Clearing Up the Smog

Debunking Industry Claims that We Can't Afford Healthy Air

Prepared for Earthjustice

September 10, 2015

Figure 1. Cost curve for known NOx emissions reductions from EPA (solid line) with NERA marginal cost curve

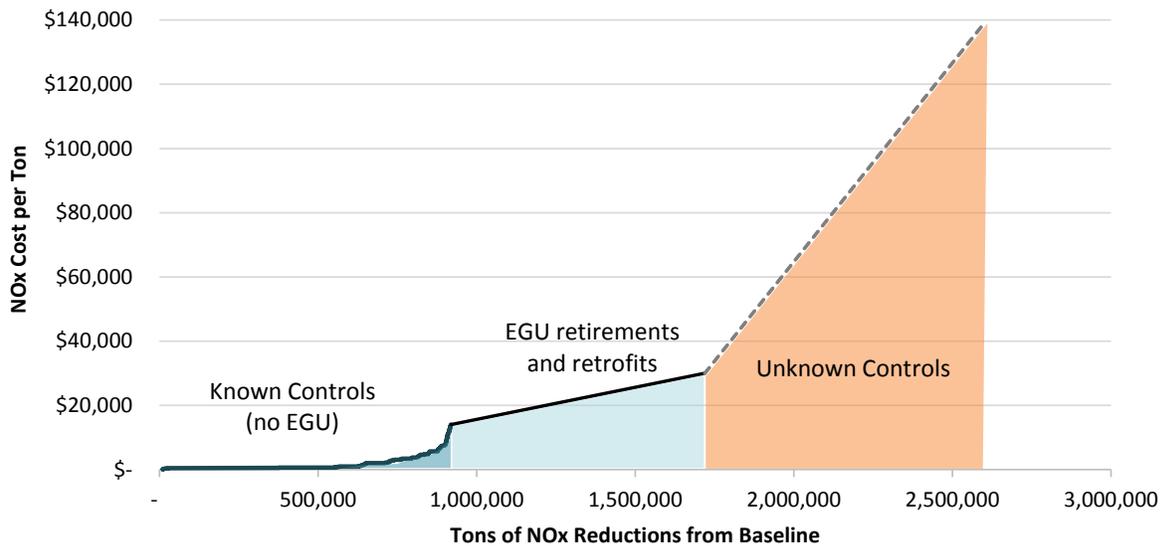
The result of NERA’s assessment is shown in Figure 1, below.⁴² The structure follows the cost curve shown by NERA in a presentation to EPA (see Figure 2b).

- The light blue section is a rough estimate of NERA’s cost of controls for EGU retirements and retrofits, covering another 800,000 tons. NERA states that these costs average about \$16,000/ton and rise as high as \$30,000/ton. NERA does not show the cost of this segment, but we would estimate it at about \$17.6 billion.

Regardless of the error, it becomes readily apparent that the vast majority of the costs assumed by NERA are driven by the assumption that the marginal cost of abatement for NOx is driven by the extremely high cost of the CARS program. In fact, NERA states that the orange area of the curve in the “unknown controls” region is over ten times larger than the combined known and unknown controls regions of EPA’s assessment. The massive wedge of costs is driven by a single endpoint: NERA’s assumed cost of marginal abatement at \$500,000/ton.

Figure 2. Cost curves for NOx reductions from NERA’s ozone studies.

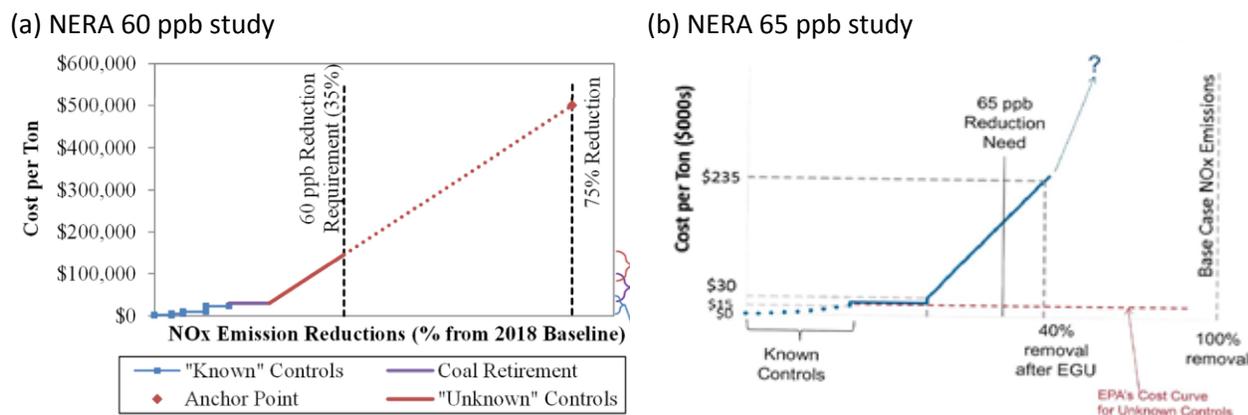
NERA oft cites a \$500,000/ton NOx marginal cost of abatement widely, but nowhere in either the 60 or 65 ppb studies does NERA show the definitive emissions reduction level associated with this dollar figure. Deep in the appendix (C-11), the 60 ppb study indicates that \$500,000/ton corresponds to a 75% emissions reduction from a baseline level, which suggests 7.3 million tons of reductions are available below that cost. Of course, neither the 60 nor the 65 ppb standards would require 75% emissions reductions, so this value does not get used directly. Instead, NERA assumes a requirement of 3.9 million tons of reductions, from which we might deduce a marginal cost of about \$197,000/ton NOx.⁵⁵ This value is not stated in the study. Rather, the only form of confirmation is a figure in the paper with a 60 ppb line that appears to cross the supply curve at about \$150,000/ton NOx (see Figure 2a, below). To add to the confusion, this line reads “35% reduction,” which is inconsistent with NERA’s own assumptions about the amount of reduction required to reach 60 ppb (a 40% reduction).⁵⁶

In a June presentation to EPA,⁵⁷ NERA shows a cost curve with \$235,000/ton pegged to a 40% reduction "removal after EGU" (see Figure 2b, above). The 40% reduction appears to be legacy from the 60 ppb study (as noted above). The cost of the 40% reduction does not line up with NERA's 60 ppb cost curve from NERA's earlier study. In fact, following NERA's 60 ppb cost curve methodology, we estimate that NERA has inflated this marginal cost by nearly 45%.⁵⁸ The cost NERA states has no explanation and is impossible to derive.

As shown above, NERA provided scant information in the 65 PPB study about the shape of their NOx supply curve, leaving out essential pieces of information such as the x-axis labels in the graph (see Figure 2a&b). The curve in Figure 2b, however, is clear enough to show that the wedge of unknown controls starts at a cost of \$30,000 and rises to a cost somewhere below \$235,000. We know that the length along the bottom of their wedge is 1,000,000 tons (the amount of unknown controls required). The wedge presumably starts at 1.6 million tons (all of NERA's known controls beyond the baseline) and ends at 2.6 million tons (all of NERA's known and unknown control reductions beyond the baseline).

⁵⁸ We would expect a 40% reduction to mean 3.48 million tons of reductions from the 6.3 million ton baseline. Reviewing Figure 2b, the y-axis is at zero tons of reductions from the baseline. Known controls account for 0.8 million tons, EGU controls account for another 0.8 million tons (1.6 million). Of the remaining 4.7 million tons to reach zero emissions, 40% is 1.88 million tons. Therefore, the "40% reduction after EGU" can be reasonably interpreted as 1.6+1.88, or 3.48 million tons. Following the methodology of footnote 55, this implies a cost of \$163,000/ton, not \$235,000/ton.

Figure 3. Slide from NERA presentation given at TCEQ.⁶²

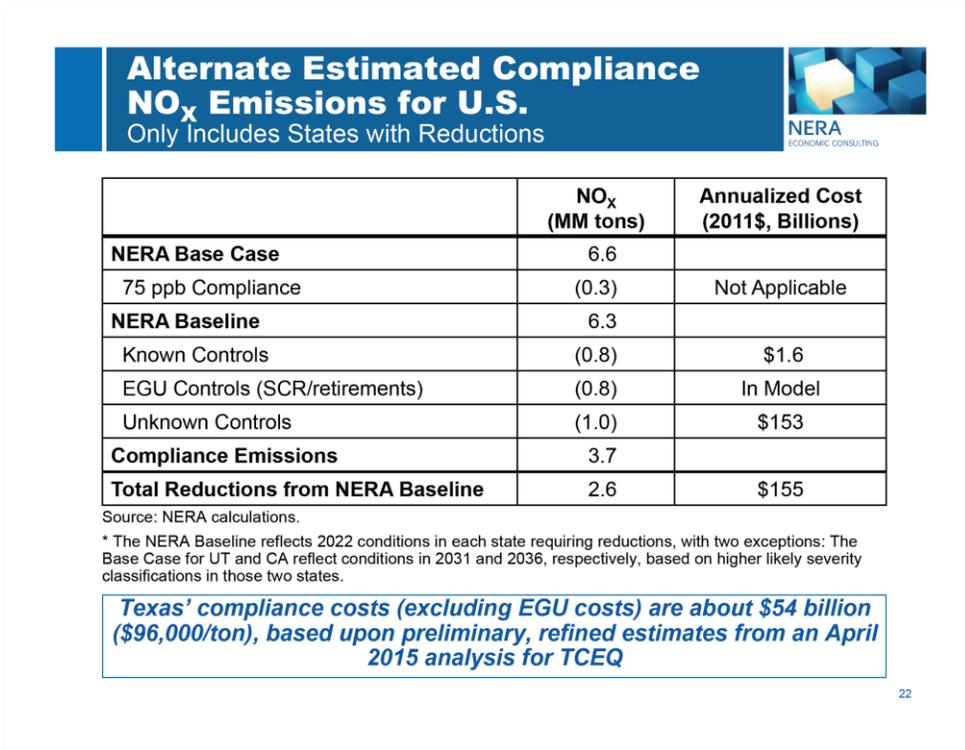
^{60,61} (see Figure 3, below). In fact, of NERA’s \$155 billion annual cost of compliance, \$153 billion (or close to 99%) is driven by NERA’s assumed cost of unknown controls.

This \$153 billion figure, presented to EPA and TCEQ, is curiously absent from NERA’s formal paper provided to NAM. In fact, the NAM paper shows annual costs that never exceed \$115 billion per year (in 2014 dollars) (see Figure 4) NERA fails to explain this glaring inconsistency.⁶³

Figure 4. Figure from NERA's 65 ppb study showing annual compliance costs.

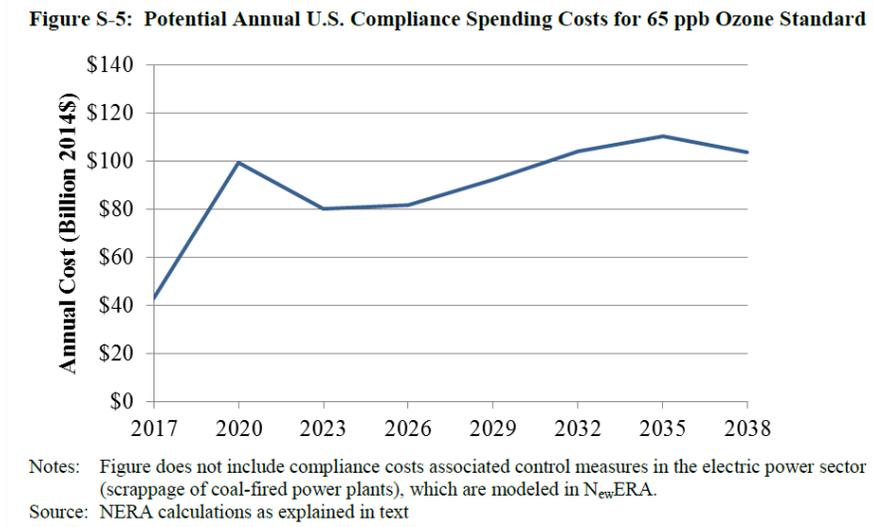
How might NERA have come up with \$153 billion in annual costs? Through a simple mistake with extraordinary consequences.

As noted previously, NERA's 65 ppb study shows total unknown control requirements at 1.8 million tons (Figure S-2), but NERA ultimately attributes 800,000 tons of these reductions to coal-fired retirements and retrofits.⁶⁴ These closures and retrofits have explicit individual unit costs in NERA's assessment and are should therefore not be a part of the unknown control cost curve. In fact, NERA's illustrative cost curve shown to EPA is careful to differentiate the EGU controls from the unknown costs (see Figure 2b).

Figure 5. NERA's erroneous cost curve for unknown controls, accounting for \$153 billion in costs.

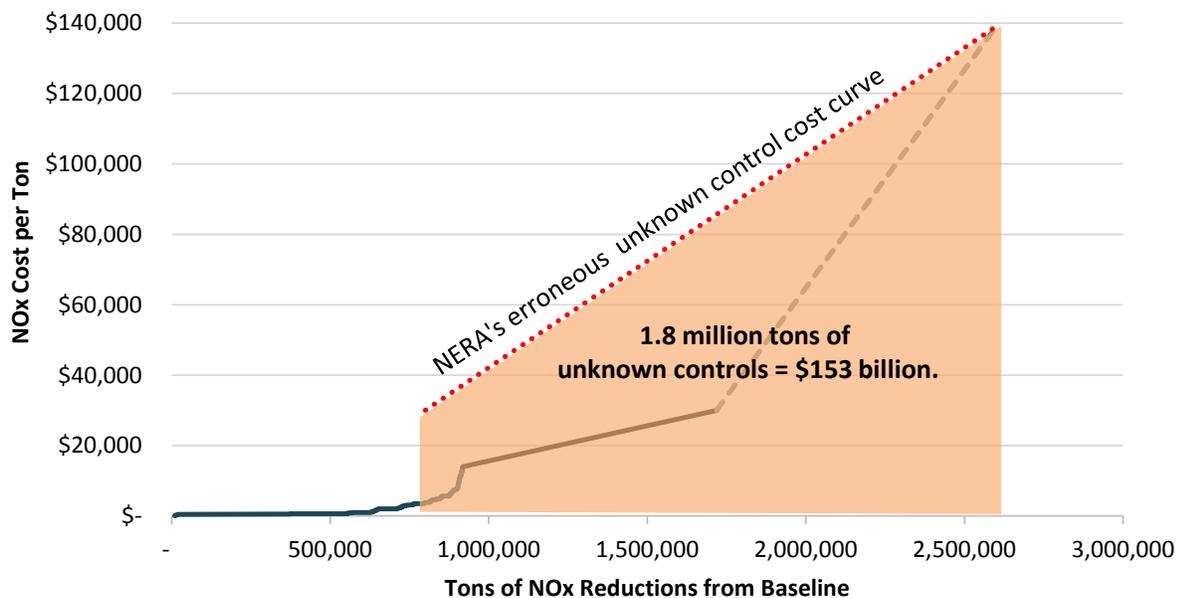
However, what if we calculate the area of the unknown cost wedge, but assume that it is 1.8 million tons long instead of just 1 million tons? We arrive at \$152 billion in unknown control costs – within spitting distance of NERA's derivation. Figure 5, below, shows NERA's erroneous cost curve for unknown costs, replacing the known cost of EGU controls and retrofits with generic and notional unknown costs, at a marginal price far in excess of reason.

NERA's derivation is wrong, double counts coal unit retirement and retrofit costs, and assigns arbitrarily high costs based on a notional curve to knowable control costs. NERA's total costs appear to be based simply on **bad math**.

Figure 6. Supply curve for NOx emissions reductions. EPA known controls, Synapse EGU controls, modified marginal abatement cost.

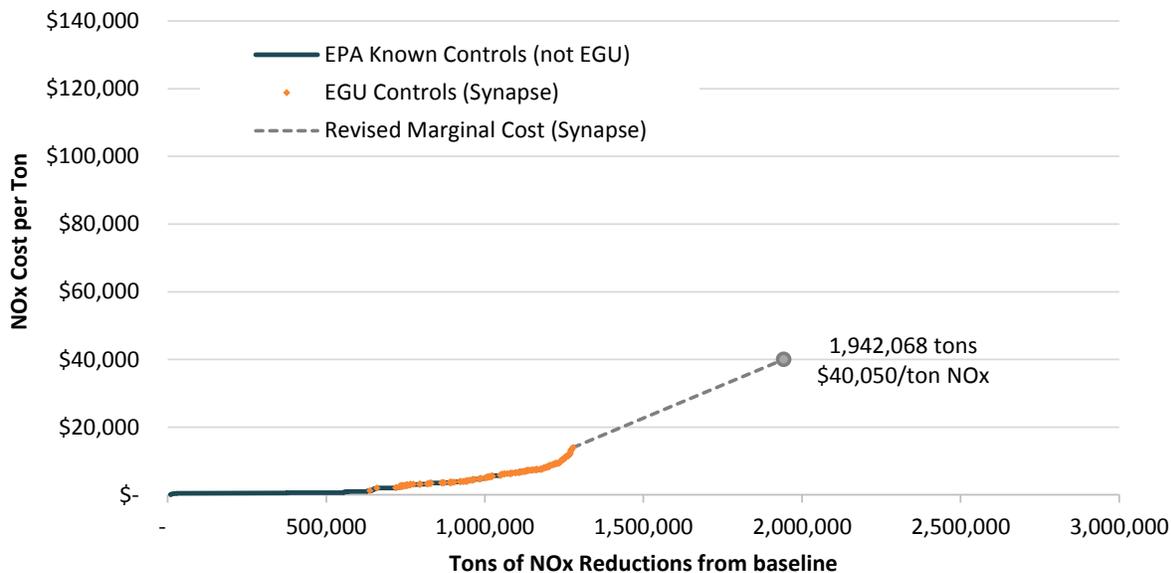
We disagree with NERA’s assessment of long-range marginal costs for vehicle emissions reductions. Based on the cost of offsets in extreme NOx stressed regions (i.e. South Coast Air District), alternative academic studies indicating a lower cost for the “cash for clunkers” program, and the assumption that even vehicle scrappage programs could be targeted more effectively, we believe NERA’s marginal cost to be unreasonable. For the purposes of this re-assessment, we maintain a marginal cost curve similar in nature to NERA’s, but reduce the marginal cost of abatement by 50%, a reduction that is conservative compared to the broader range of costs implied by the Li, Linn, & Spiller paper. We maintain NERA’s assumption that the curve is linear, starting from the “anchor point” of the highest cost known control. In this case, the highest cost known control is a \$14,000 / ton SCR (see Figure 6, below). Following the curve from the anchor to the marginal abatement cost, we arrive at a \$40,000/ton maximum cost for unknown controls.

Overall, known controls identified by EPA and additional SCR control and retirement costs identified by Synapse amount to \$3.7 billion (annualized).⁷⁶ The additional cost of unknown controls (using NERA’s cost-curve approach) would be \$17.9 billion (annualized). In total, we estimate that under NERA’s cost-curve approach, the cost of the 65 ppb ozone standard should be \$21.6 billion (annualized) – far below NERA’s erroneous \$155 billion estimate.
